SUBJECT: COMANCHE PEAK STEAM ELECTRIC STATION
DOCKET NOS. 50-445 and 50-446
CONTAINMENT SUMP PERFORMANCE

TEXAS UTILITIES GENERATING COMPANY
COMANCHE PEAK STEAM ELECTRIC STATION
Containment Paint Evaluation -
Reply to NRC Questions

CONTAINMENT PAINT EVALUATION - REPLY TO NRC QUESTIONS

FIGURE 1

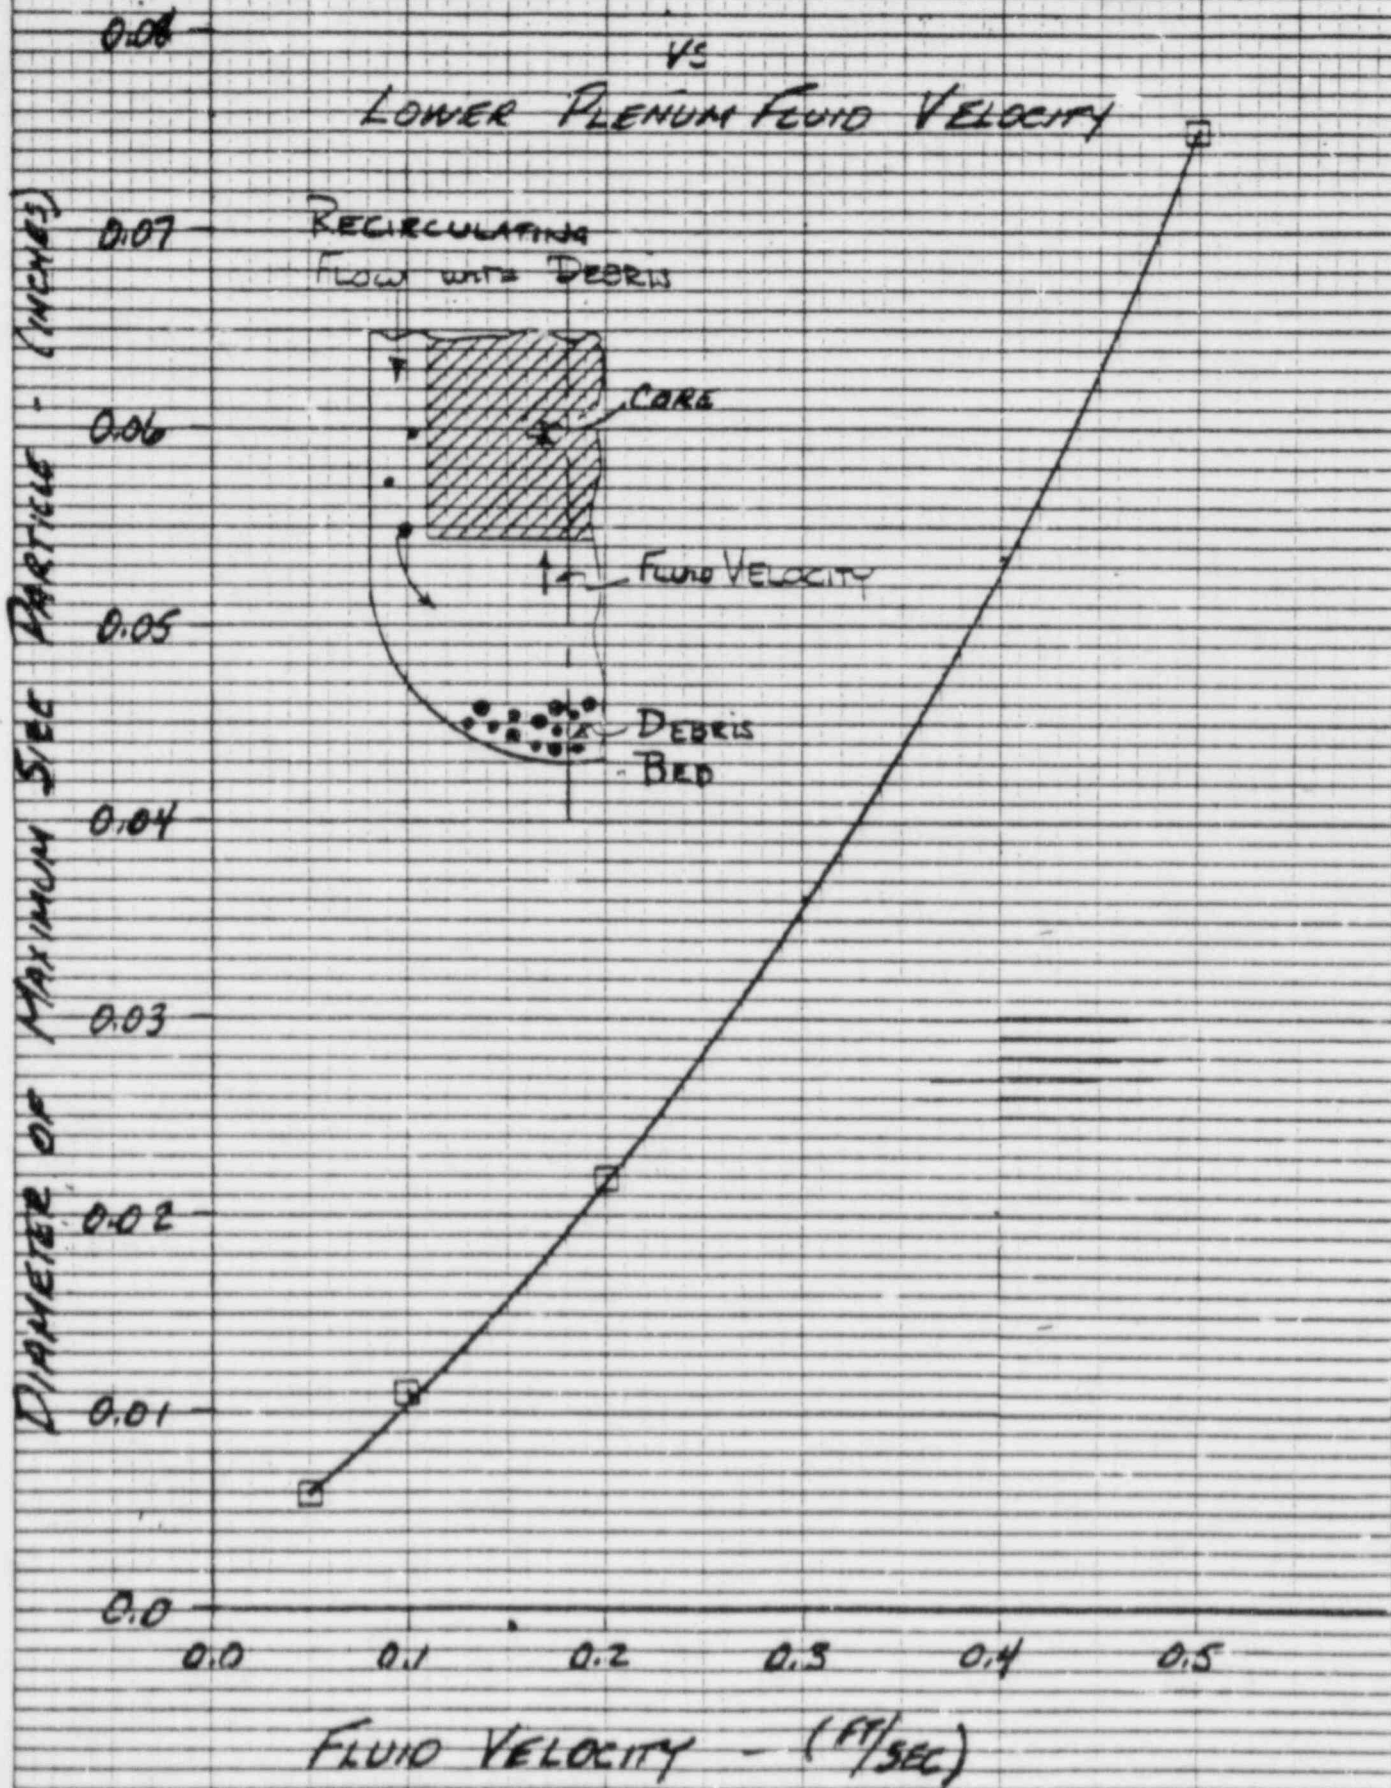
3) What is the impact of paint fines on the core?

Using the preceding assumptions and performing a force balance that accounts for drag, gravity, and hydrostatic forces, a relationship identifying the maximum debris particle size that can be carried by a vertically flowing fluid with a given velocity was developed. A plot of that relationship is given in Figure 1.

The vertical velocity of the recirculating fluid in the lower plenum prior to its passing through the core support plate will determine the maximum debris size that can be carried into the core. A typical fluid velocity in the core during cold leg recirculation following a cold leg break is 0.1 ft/sec. Using the core velocity to evaluate a conservatively large debris particle size, the data of Figure 1 indicates that the maximum size of debris passing through the core will be about 0.011 inches in diameter.

Thus for two RHR pumps operating, the fluid velocity in the RV/core barrel annulus is sufficient to reentrain debris that may cause core blockage if it is reintroduced to the RV. From Figure 1, it is concluded that if the fluid velocity in the lower plenum is less than 0.33 ft/sec, only debris that is less than 0.040 inches in size may be entrained. Typically, the fluid velocity in the lower plenum is a maximum where the fluid turns to flow up the downcomer. Figure 3 shows the relationship between vessel flow rate, debris bed height, and fluid velocity as it turns into the downcomer from the lower plenum. From Figure 3, the velocity of the turning fluid is predicted to be below 0.30 ft/sec for debris beds less than 4.7 feet in height. From Figure 4, which is a plot of vessel volume versus vessel height, the debris bed
